BELL SYSTEM PRACTICES
Teletypewriter and Data Stations

ADDENDUM P34.309
Issue 1, February, 1963
AT&TCo Standard

**28D, D-1, D-2, K AND U ELECTRICAL
SERVICE UNITS FOR 28-TYPE
TYPING REPERFORATOR**

28D AND 28U ELECTRICAL SERVICE UNITS

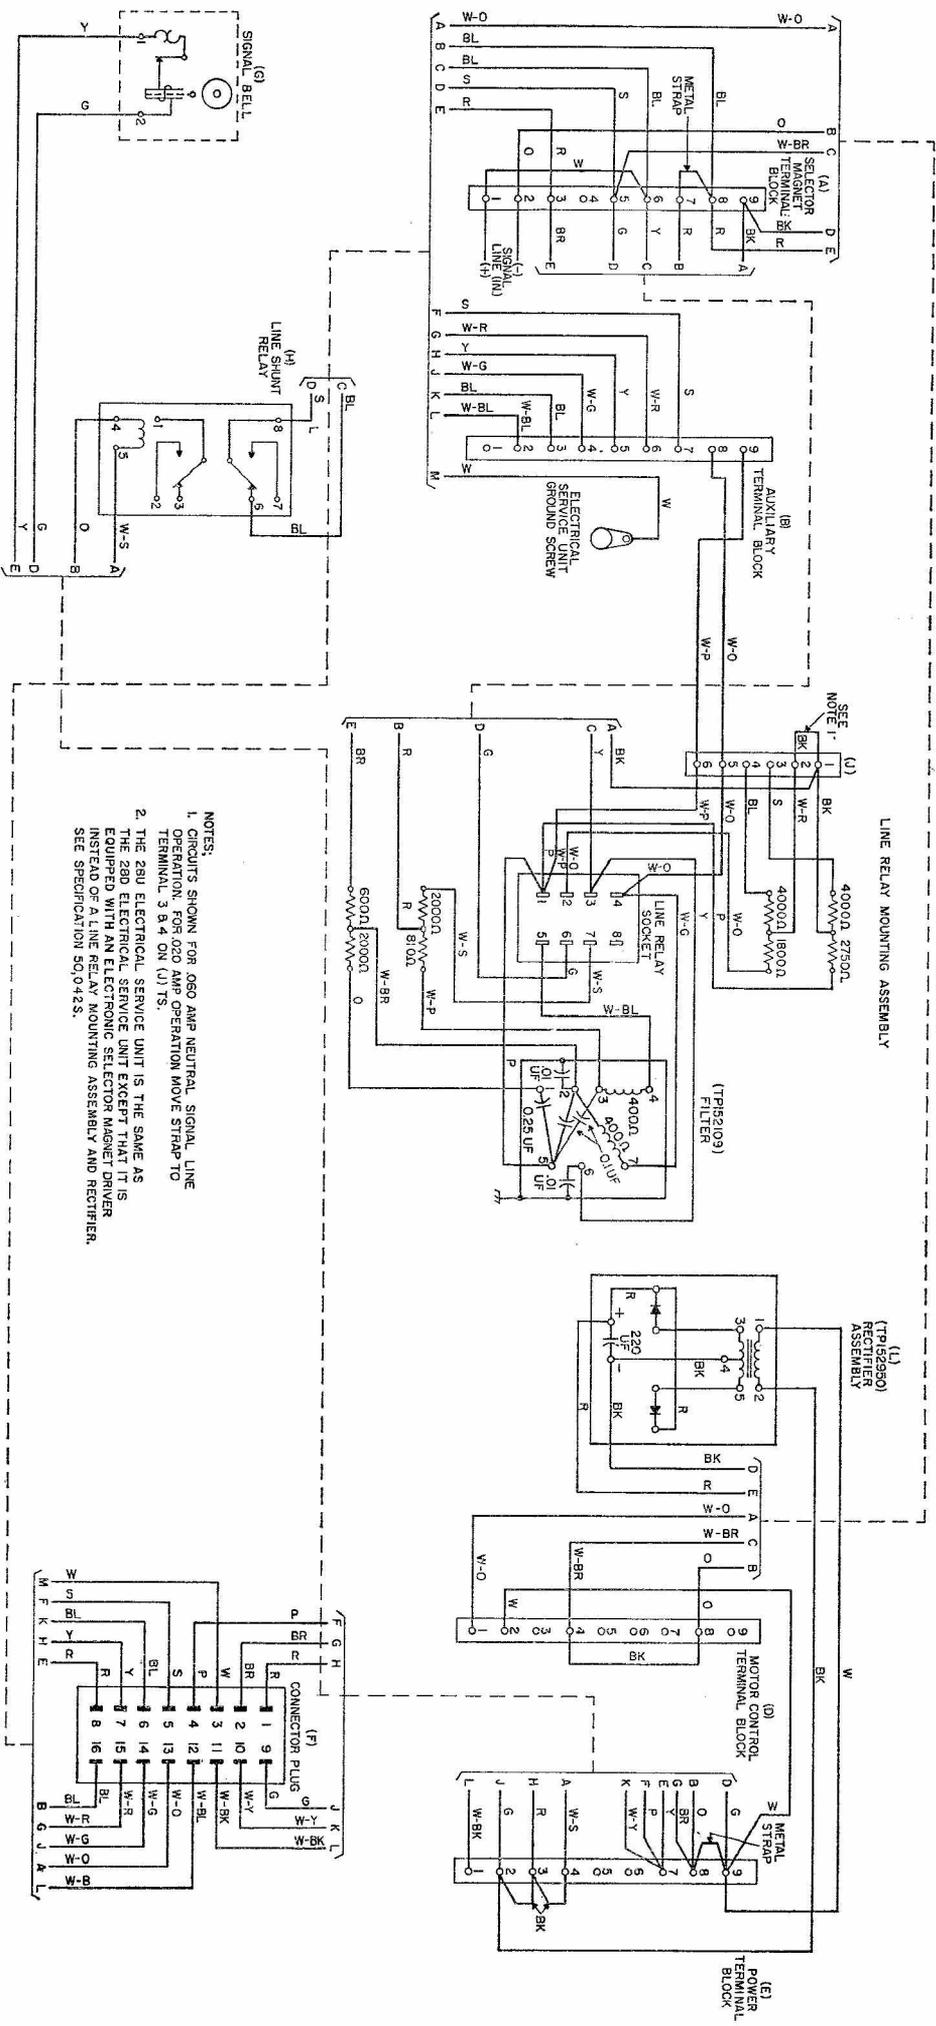
- 1.001 This addendum supplements Section P34.309, Issue 3.
- 1.002 This addendum is issued to add the wiring of the 28U electrical service units, and to change the title accordingly.

- NOTES:
1. CIRCUITS SHOWN FOR 200 AMP NEUTRAL SIGNAL LINE OPERATION. FOR 100 AMP OPERATION MOVE STRAP TO TERMINAL 3 & 4 OR (J) 7 & 8.
 2. THE 28U ELECTRICAL SERVICE UNIT IS THE SAME AS THE 28D ELECTRICAL SERVICE UNIT EXCEPT THAT IT IS EQUIPPED WITH AN ELECTRONIC SELECTOR MAGNET DRIVER. SEE SPECIFICATION SO.0442S.
